# January 10, 2024

Submission to Regional Municipality of Niagara  
Planning and Economic Development Committee  
ROPA for Port Colborne Quarries Pit 3 Extension

PDS-C 4-2024

DETAIL 5  
SKETCH OF SECOND CONCESSION  
ROAD SETBACK.

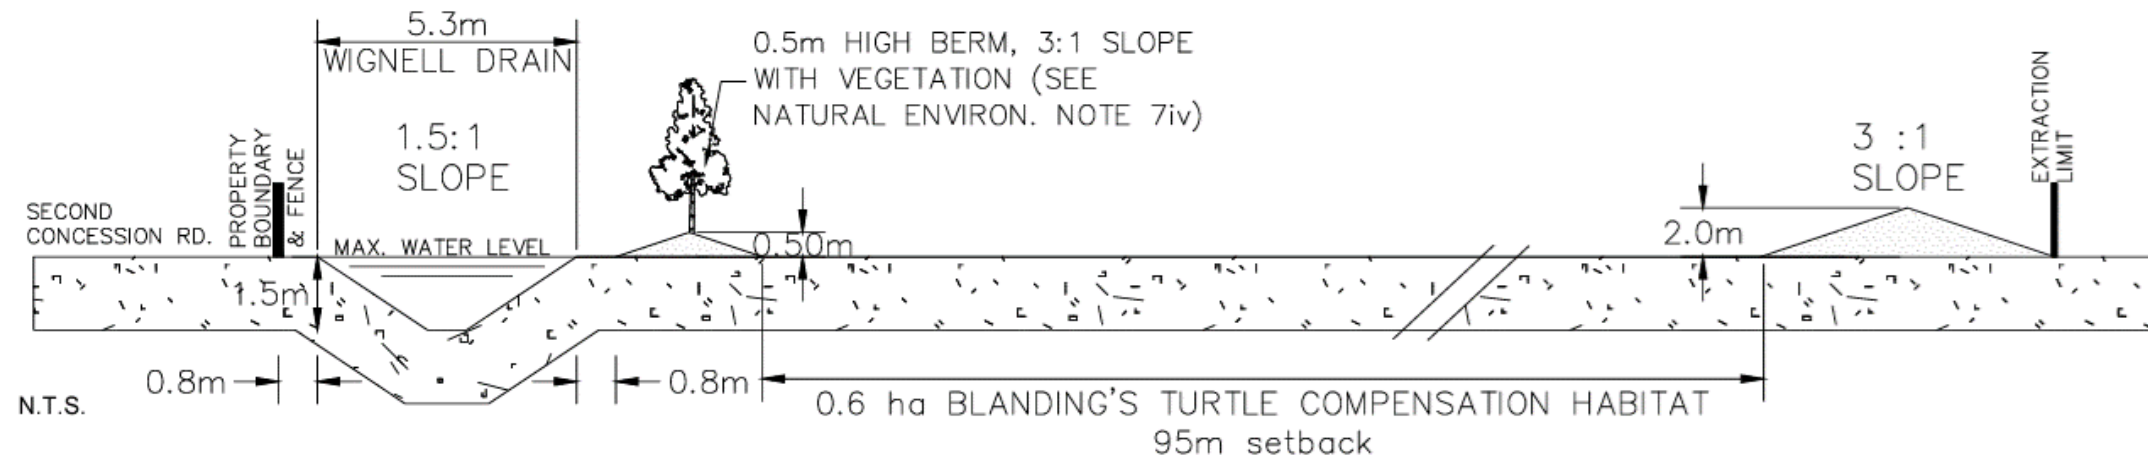
The proposed realignment of the Wignell Drain along Second Concession Road will encroach into the north of the Locally Significant Wetland. At the south wetland limit the agreement with MNRF is to maintain a 30 m BUFFER between the licensed area and the wetland. 30 m should also apply to the north between the drain and the wetland.

# SKETCH 1 - PROGRESSIVE STATUS OF THE WIGNELL DRAIN

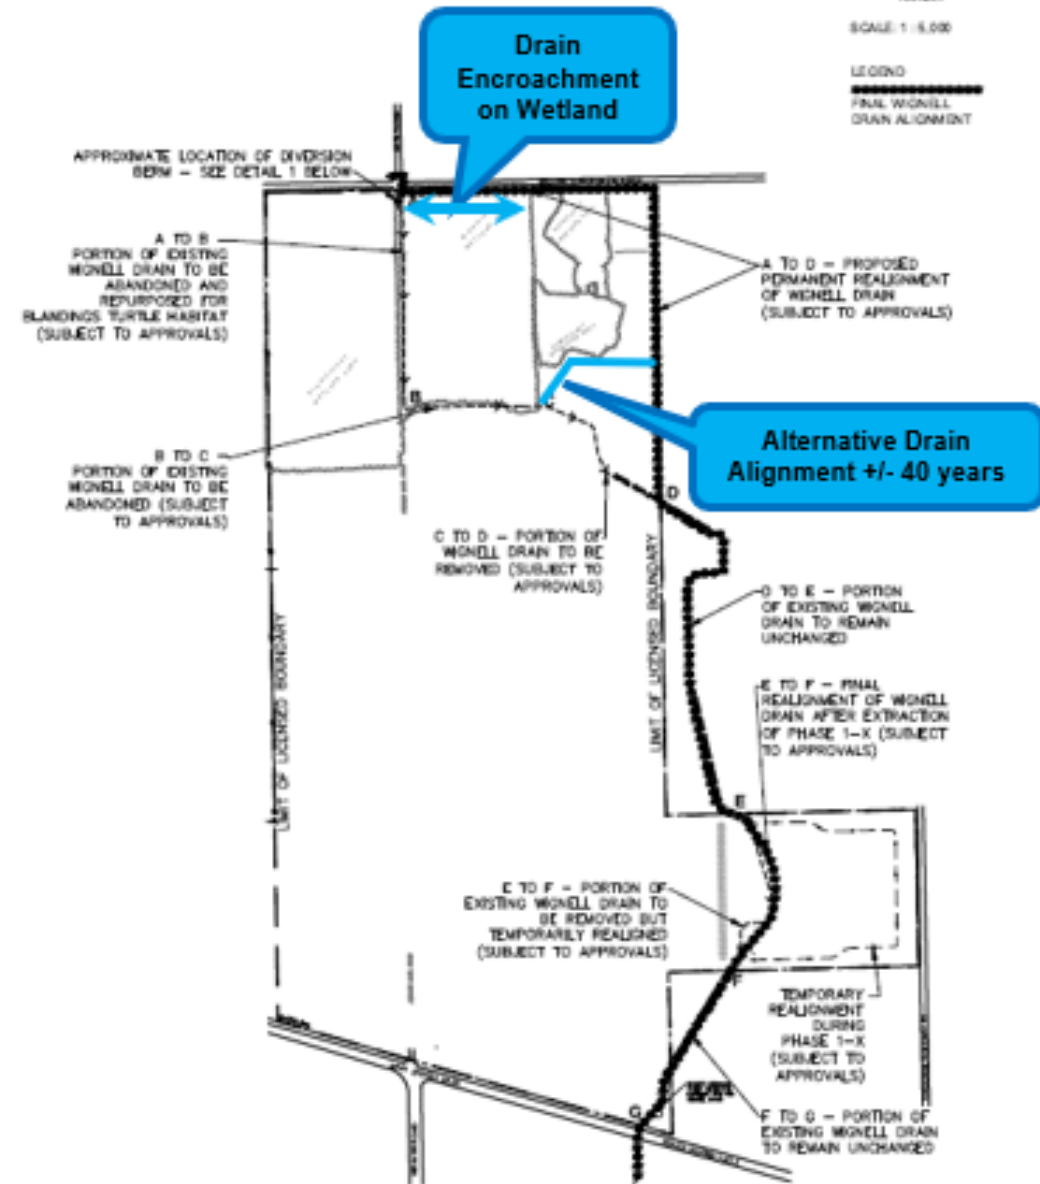
- The currently proposed major realignment of the Wignell Drain north reach is proposed to be conducted immediately even though it is not needed for 40 years
- The proposed alignment will encroach on the north of the wetland east of Carl Road, whereas it should maintain the 30 m BUFFER
- There are very good, non-habitat-threatening options to the major realignment
- A minor realignment, similar to the east tab, is only ¼ as long as the proposed realignment and poses NO risk to the wetland and endangered species therein as it will function exactly as it has for the last century, and can be done just before advancing to these lands.

# Volume of aggregate in Phase 3X

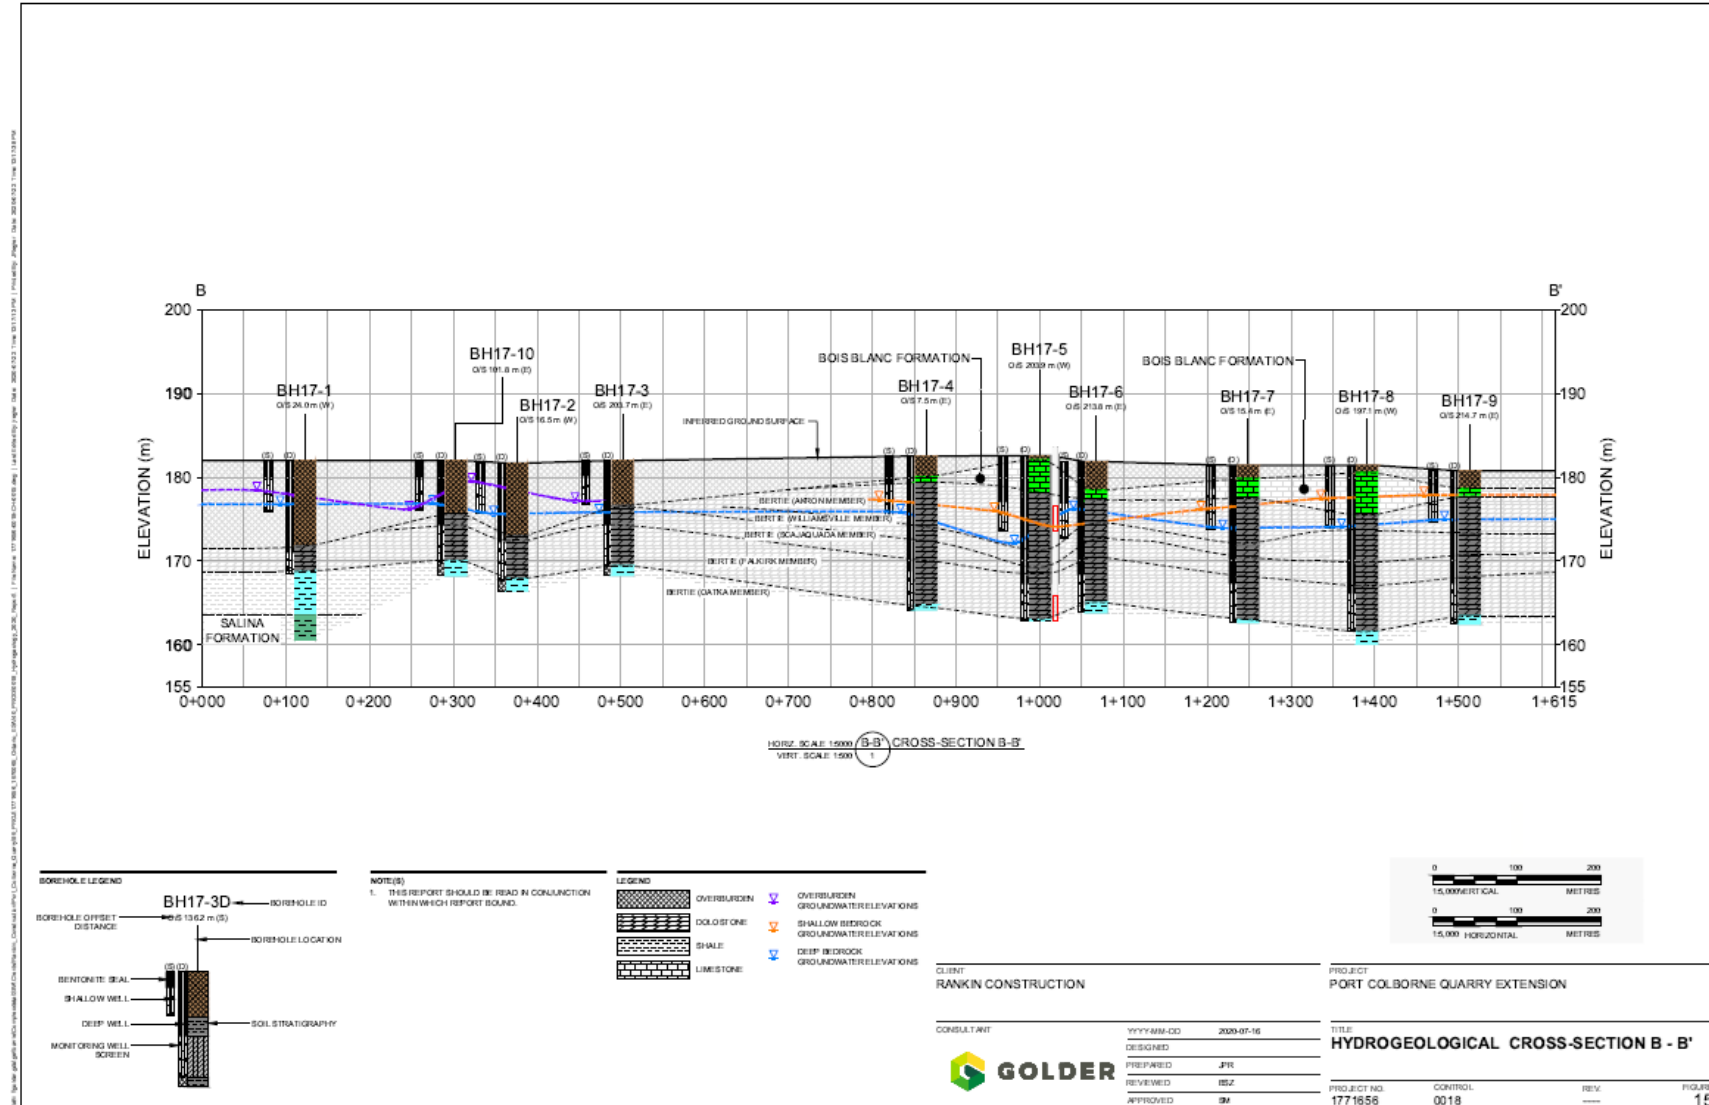
- a. Calculated Reserves: Comments from the public asking whether it continues to make sense to extract the 'northern finger' (Phase 3) given its ongoing reduction in size and limited width.

### **Response:**

The initial volume of stone within Phase 3 as part of the 2021 submission was approximately 311,000 tonnes. The area was reduced due to the Blanding's turtle habitat and the increased setback to the Significant Wetland Area, and the volume of stone is calculated to now be approximately 231,000 tonnes. It is PCQ Inc. opinion that this volume continues to be sufficiently large to be economically efficient to extract, and as wise stewards of the resource, is important to make it available to the local market.

# Reduction of viable rock area

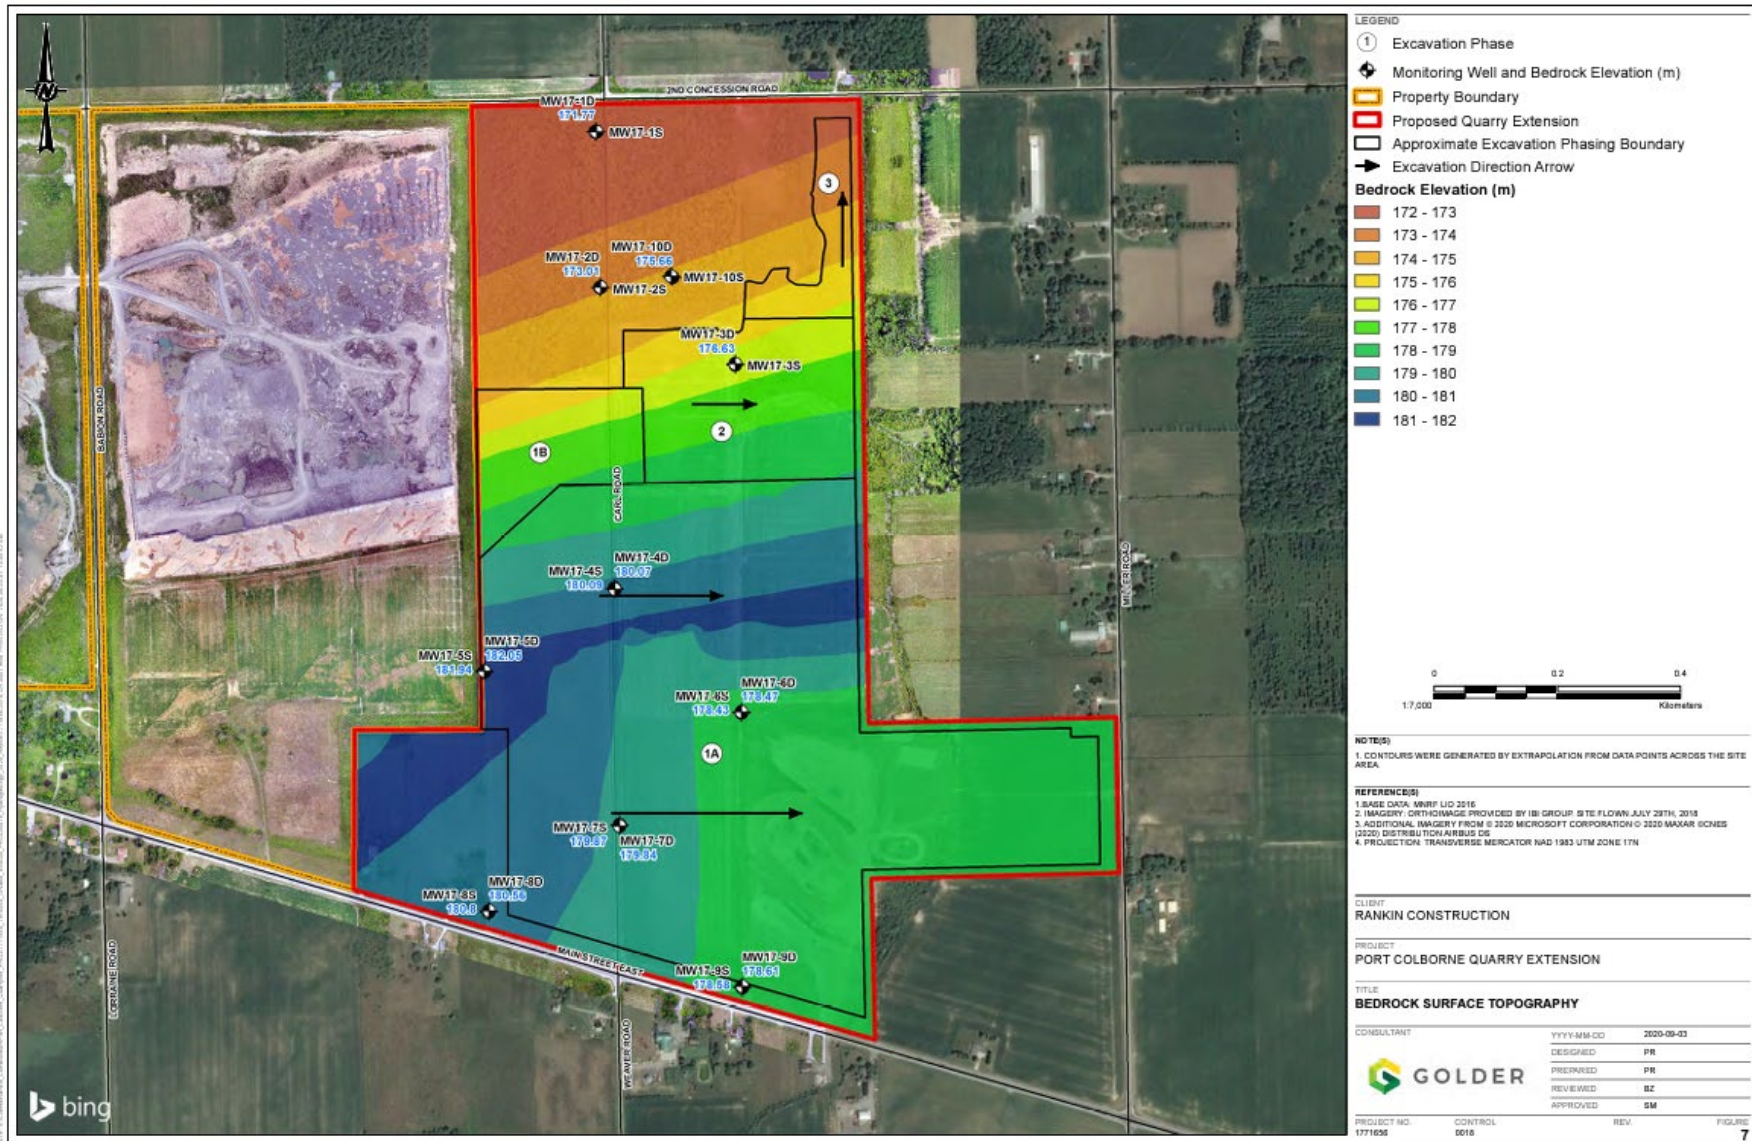
- The north tab has an overburden thickness of 8 – 10 m (see next slide)
- The overburden is earth and clay, and cannot be excavated vertically
- By Ministry of Labour regulations, a 1:1 slope is required
- This means the footprint is reduced by a width equivalent to the overburden depth
- A 6,700 m<sup>2</sup> area of 100 m length has a width of 67 m. This is reduced by 20 m south of the turtle habitat for the proposed drain and maintenance area.
- This is reduced to 47 m to 51 m width at the rock surface, or a reduction of an additional 25 – 30%
- Based on the above and the published maps, the recoverable aggregate has been overestimated by 125% - 130%

# “Significant Volume” of Rock in North Tab

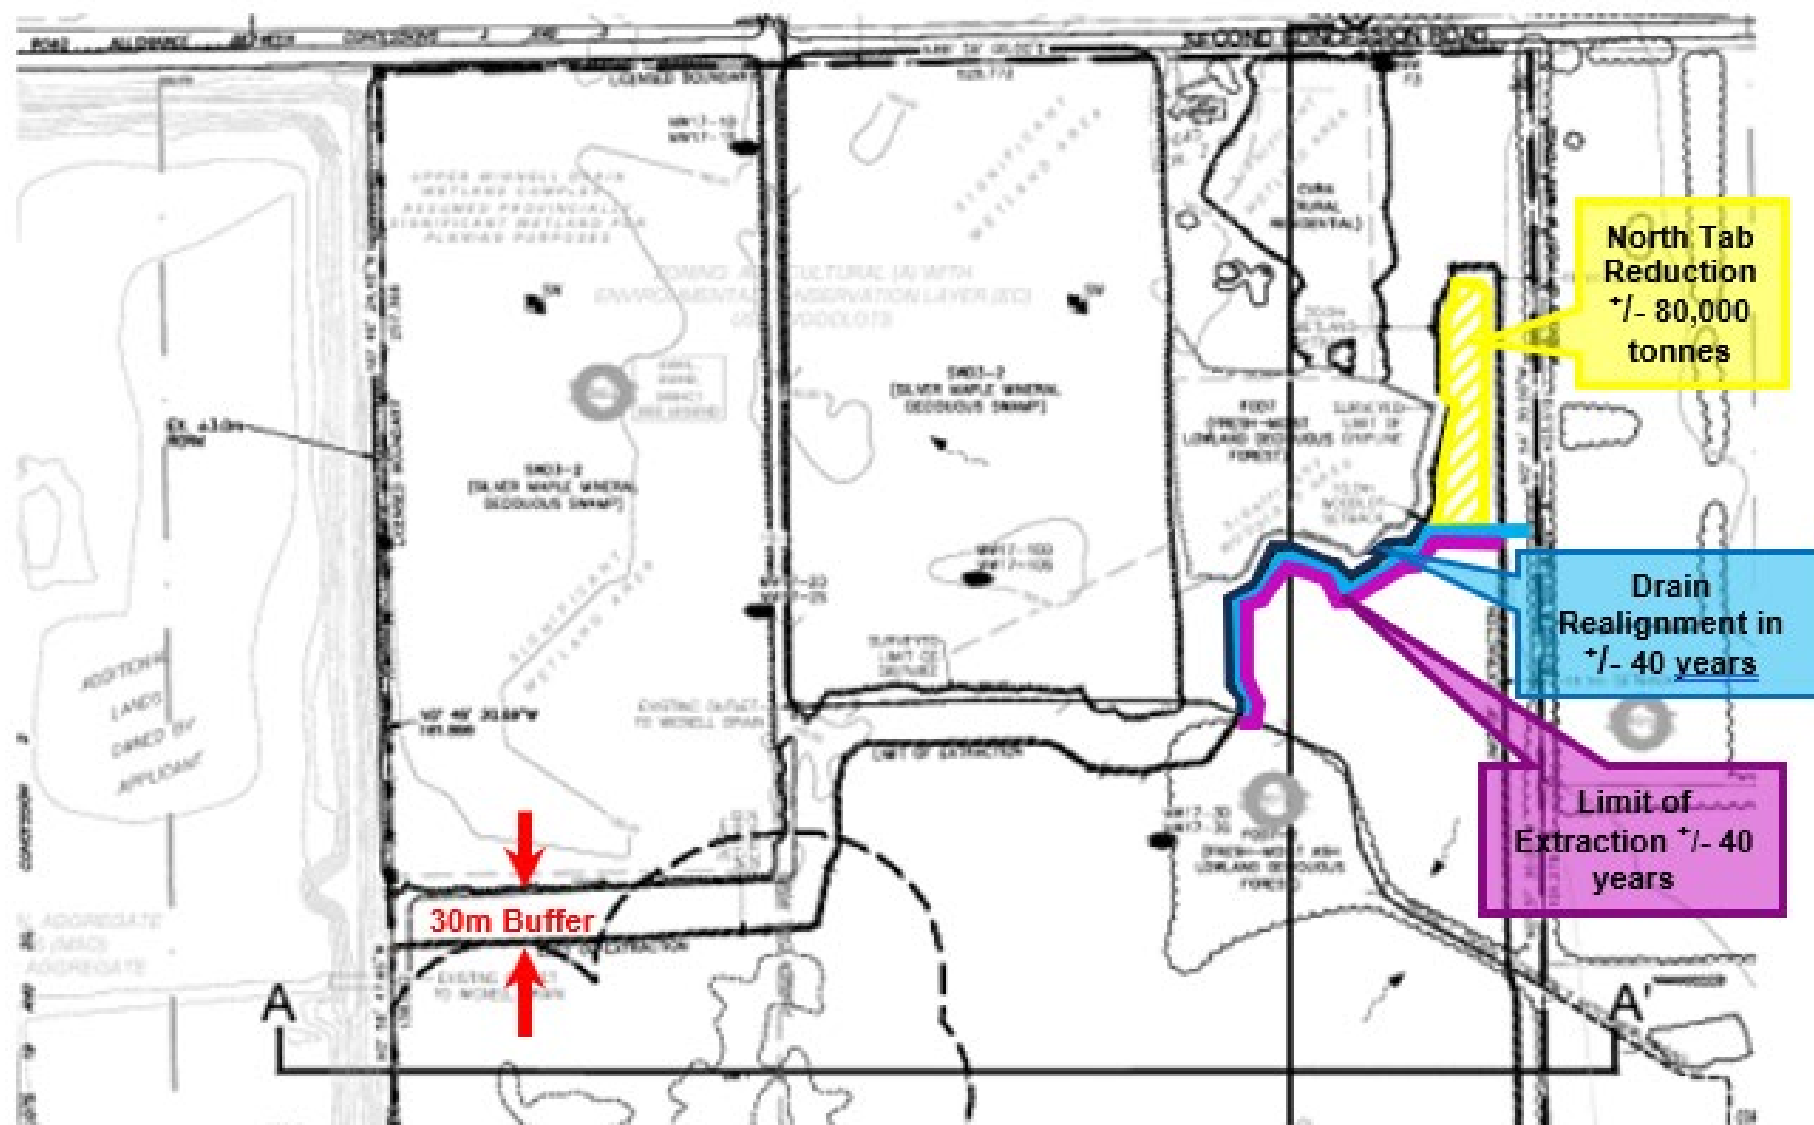
- The Proposed Turtle habitat pond takes up 95m of the North Tab (Slide 11) and reduced the available aggregate resource volume by 80,000 tonnes (Previous Slide (13))

- Reducing the North Tab another 95m will potentially reduce the available aggregate resource by another 80,000 tonnes, not including the reduction due to **sloping requirements for the 8 – 10 meters of overburden**

- The total estimated volume of the Pit 3 extension/expansion is 40,000,000 tonnes over the 40+ years (480+ months) of estimated quarry life
- A further reduction of 95m of the north tab is equivalent to 0.2% (80,000/40,000,000) or 0.96 months of aggregate reserve in a 480+ months estimated quarry life. Just 1 month in 40 years.

- THIS IS NOT A SIGNIFICANT VOLUME AND DOESN'T WARRANT A THREAT TO THE WETLAND, ESPECIALLY NOT AT THIS TIME. A SIMPLE REALIGNMENT IN 40 YEARS SIMILAR TO THE EAST TAB REALIGNMENT WILL SUFFICE
